### **MILWAUKIE PLANNING COMMISSION Tuesday, December 9, 2014, 6:30 PM**

- 5.0 Public Hearings** – Public hearings will follow the procedure listed on reverse
  - 5.1 Summary: Reliable Credit Parking Lot  
Applicant/Owner: Sisul Engineering/L & B Holzman LLC  
Address: 10605 SE Main St  
File: DR-14-07  
Staff: Vera Kolias

**To:** Planning Commission

**From:** Vera Kolias, Associate Planner

**Landscape Plan**

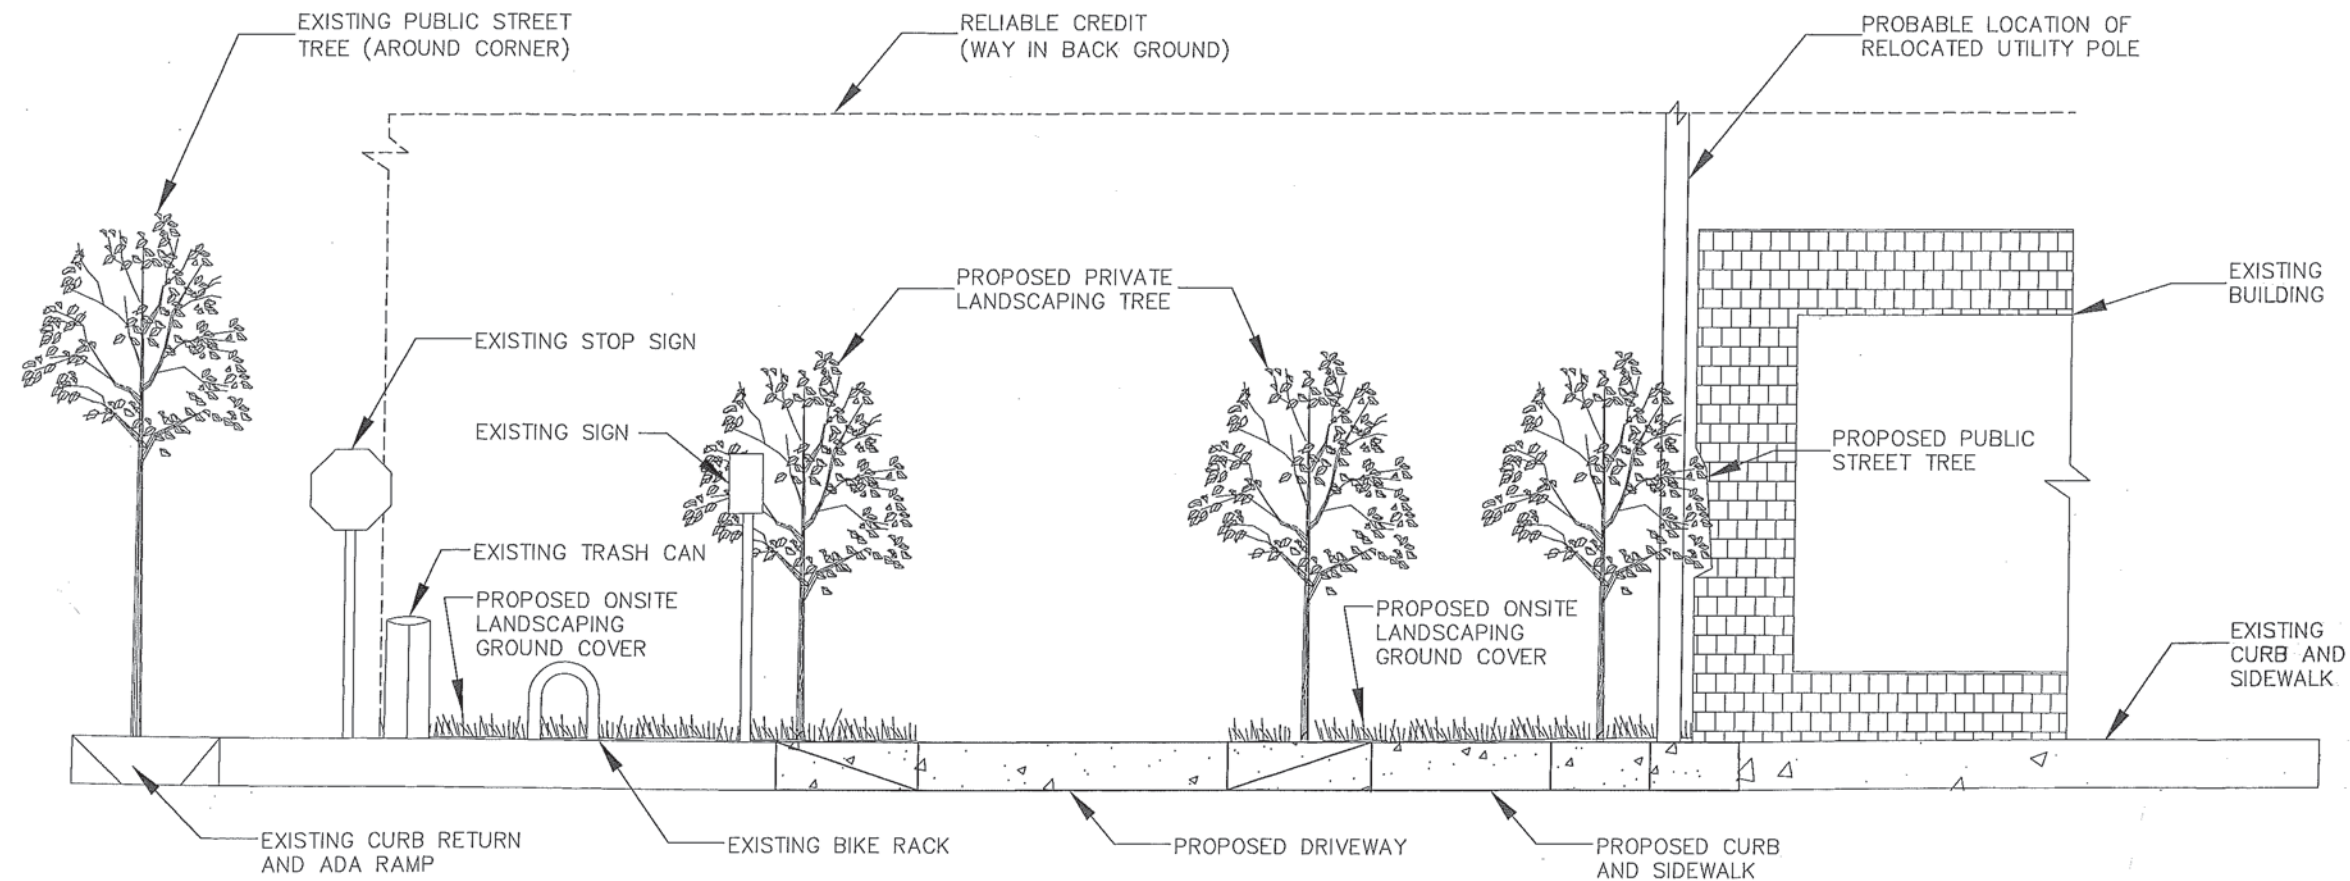
In downtown zones, perimeter landscaping areas are not required along lot lines abutting other properties but must be at least 4 ft wide when abutting a right-of-way. At least 1 tree must be planted for every 40 lineal feet of landscaped buffer area, with the remainder of the buffer planted with grass, shrubs, ground cover, mulch, or other landscaped treatment.

As proposed, perimeter landscaping areas near the public right-of-way along SE Main Street are 4 feet wide and will have at least 1 tree planted every 40 lineal feet.

At least 25 sq ft of interior landscaped area must be provided for each parking space. Planting areas must be at least 120 sq ft in area, at least 6 ft in width, and dispersed throughout the parking area. For landscape islands, at least 1 tree shall be planted per island, with the remainder of the buffer planted with grass, shrubs, ground cover, mulch, or other landscaped treatment.

As proposed, interior landscaping areas appear to provide at least 750 sq ft of area, which is nearly twice the area required. New interior landscaping areas appear to be at least 6 ft wide and at least 120 sq ft in area, with at least 1 tree planted per island.

## EasyLED 12" Area Light

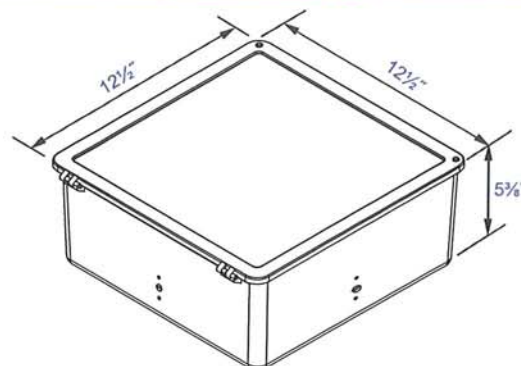
The existing parking area was developed in 1998, prior to the adoption of the Downtown Design Guidelines in 2003. The applicant originally proposed to install new parking lot lighting in the same utilitarian style as the existing parking lot features. The existing lighting fixtures (see Figure 6) do not match the ornamental style prescribed in the Downtown Design Guidelines (see Figure 7) and are "not recommended." The applicant's revised submission, provided at the DLC meeting, included four ornamental light fixtures consistent with the downtown design guidelines.

The site is physically connected to the central downtown area, where other ornamental lights have been installed; specifically, across Main St from the site and further north as well. Maintaining consistency, given there are no immediate plans to install light fixtures in this block is important. Although other downtown parking areas do not have this ornamental lighting, those lots were developed prior to the adoption of the Downtown Design Guidelines. The applicant's original proposed site plan identifies two utilitarian light fixtures on the west side of the parking lot. Ornamental lighting that is consistent with the Downtown Design Guidelines, on the street side of the parking lot rather than the west side, would be more attractive and would provide lighting for both employees using the parking lot and pedestrians on the adjacent sidewalk. Further, the Downtown Design Guidelines recommend that lighting should be located in landscaped areas wherever possible, and no lighting currently exists on that side of Main Street. The fixture location should be coordinated with the planned location of any future light fixtures installed if/when Public Area Requirements are built. Per MMC 19.606.3.F, the luminaries should have shielding for limiting light trespass.

**DLC Review:** The DLC recommended during their review and discussion at the December 1, 2014 public meeting that a combination of light fixtures, both ornamental and utilitarian were appropriate for the site. In order to provide consistency and cohesiveness, the DLC recommended that ornamental fixtures be located adjacent to the public sidewalk. To provide additional lighting for safety, the DLC recommended that utilitarian fixtures (shoebox style) could be installed in the interior of the parking lot on the west side. The DLC recommends that two ornamental parking lot light fixtures shall also be installed on the east side of the parking lot, within the planting area adjacent to the public sidewalk. These revisions would be consistent with the Downtown Design Guidelines.

1. Approve the Downtown Design Review application for the proposed parking lot construction, with conditions. This will result in the construction of a parking lot with revised light fixtures and location, and the provision of a structural edge treatment along the public sidewalk for the length of the parking lot.
2. Adopt the attached Findings and Conditions of Approval.
